**PUR-1270
ADDENDUM NO. 3
INVITATION TO BID**

CONOCOCHEAGUE TREATMENT PLANT ENR UPGRADE

DATE: Tuesday, May 10, 2016

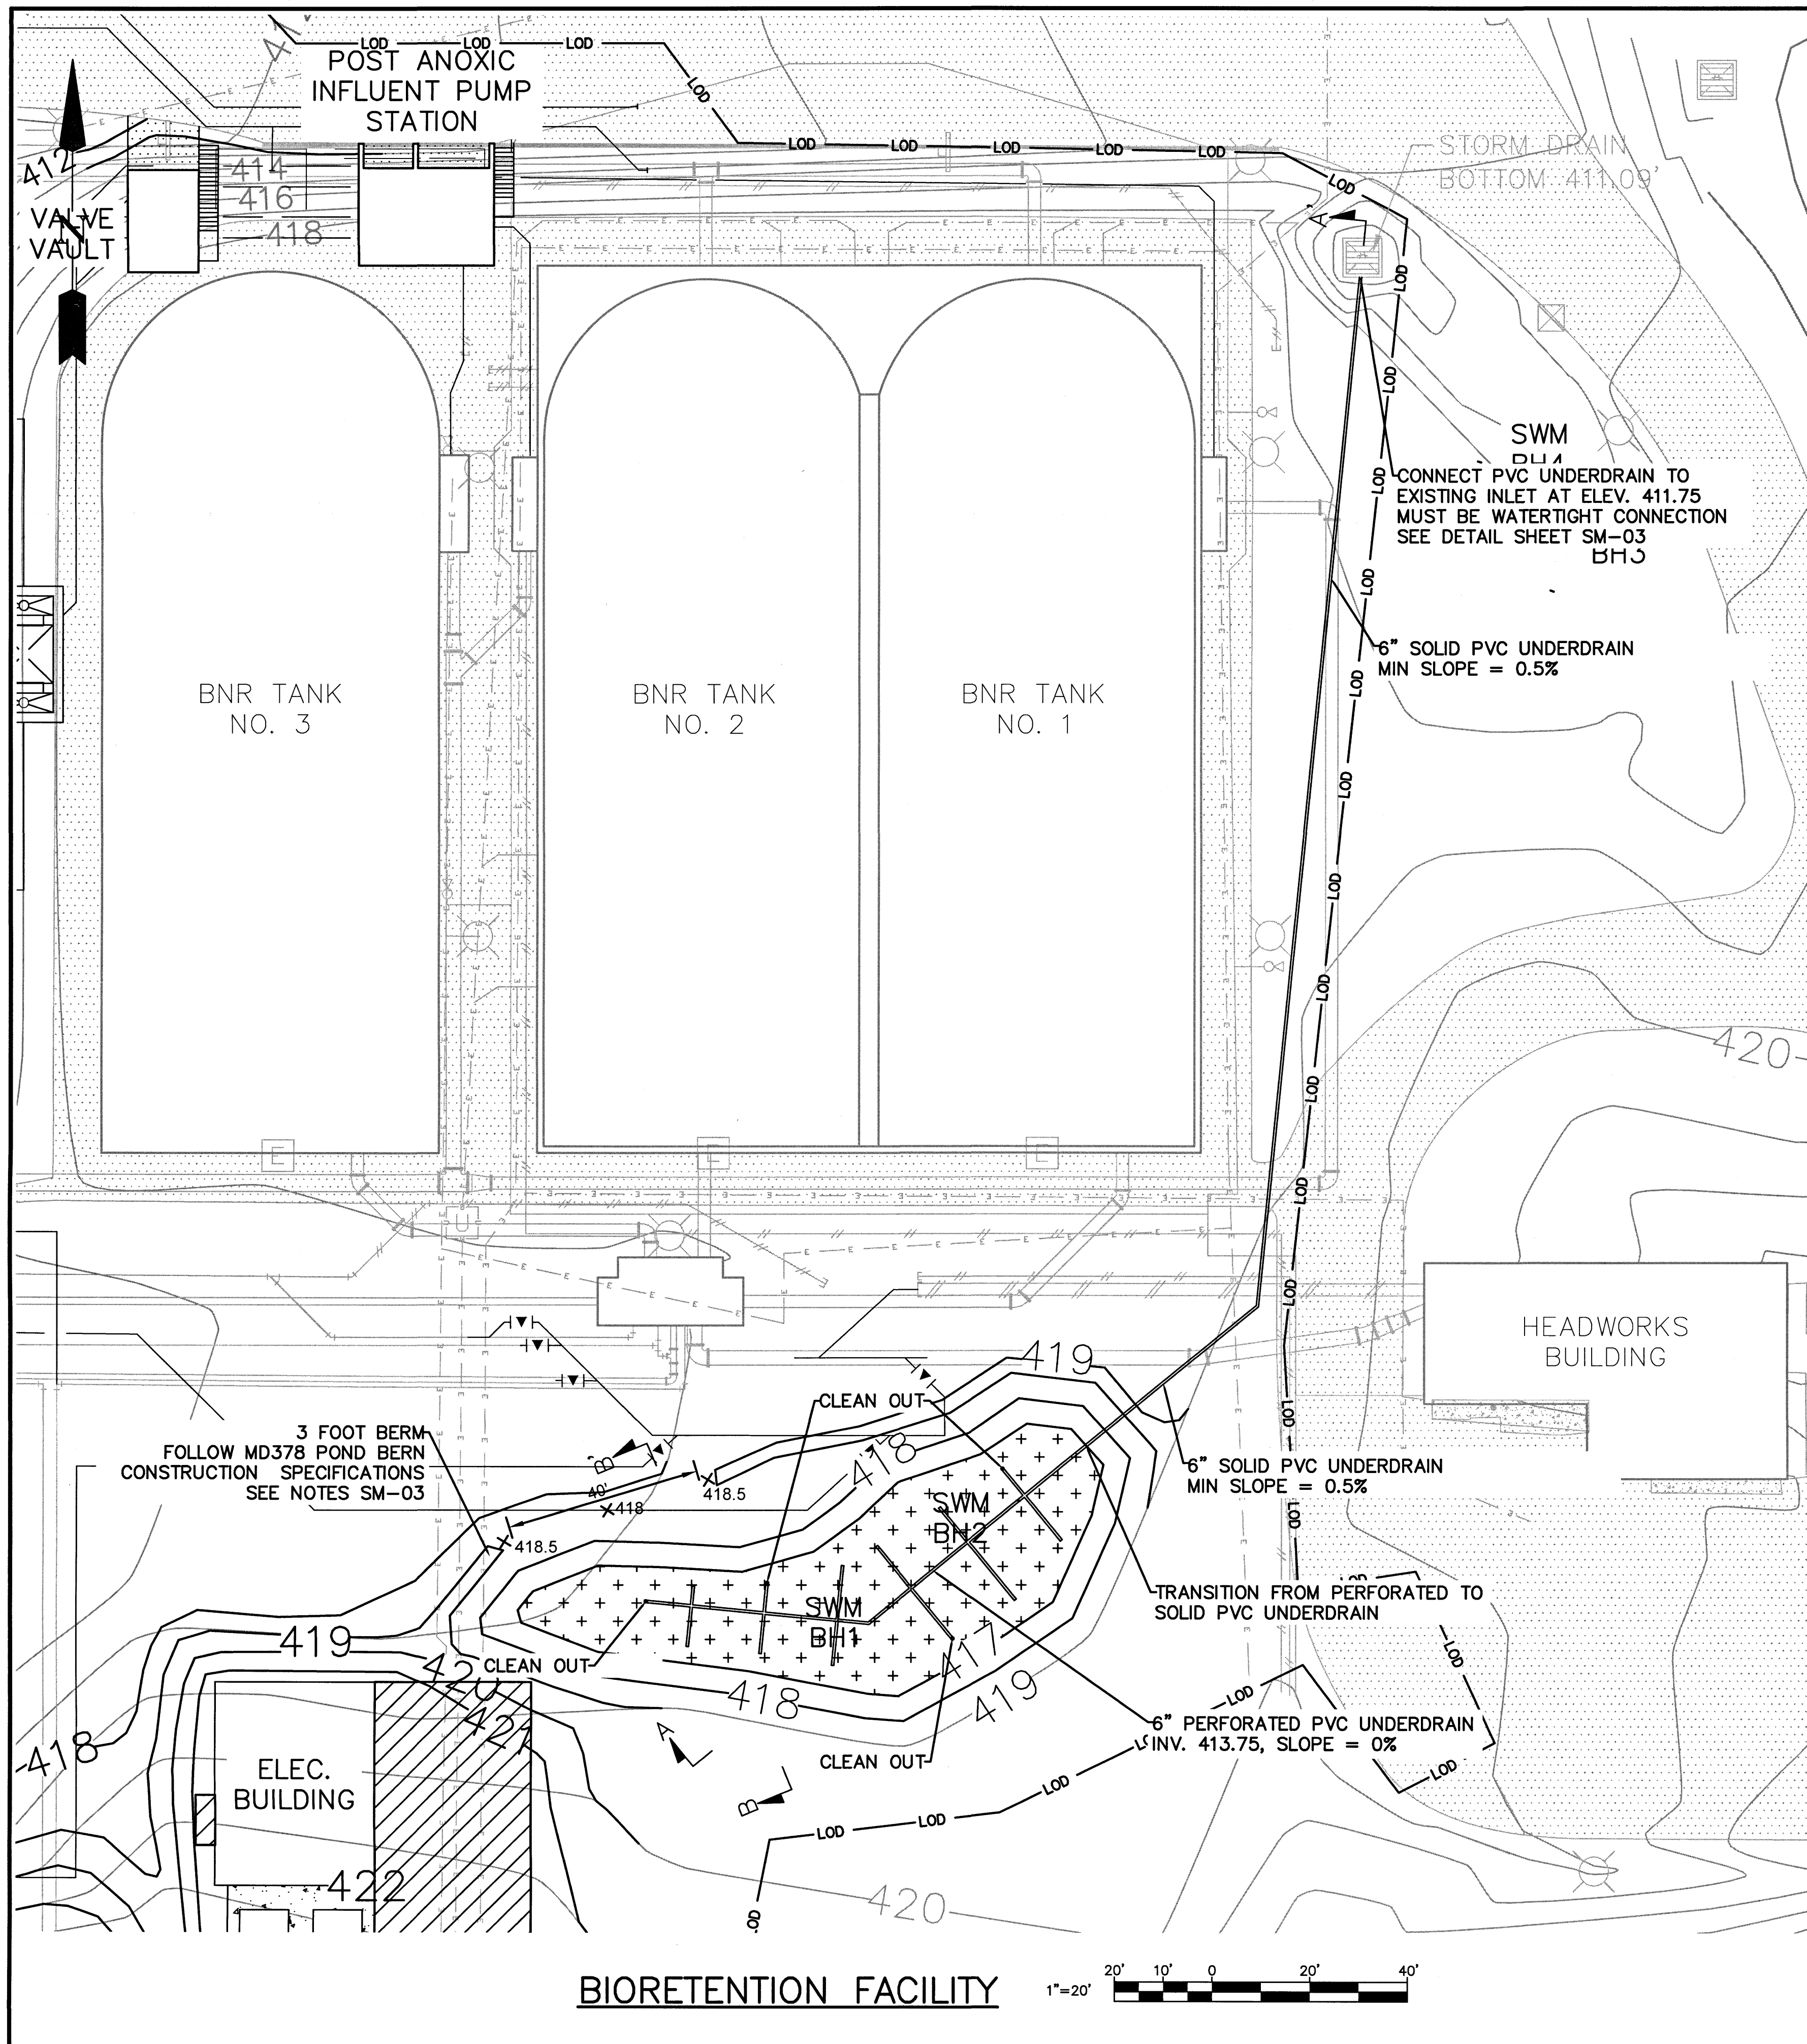
ADD 3” Ø polyethylene utility water supply line to the Bio-Mag Building per the Partial Yard Piping Plan for Drawing No. C-3 attached to this Addendum No. 3.
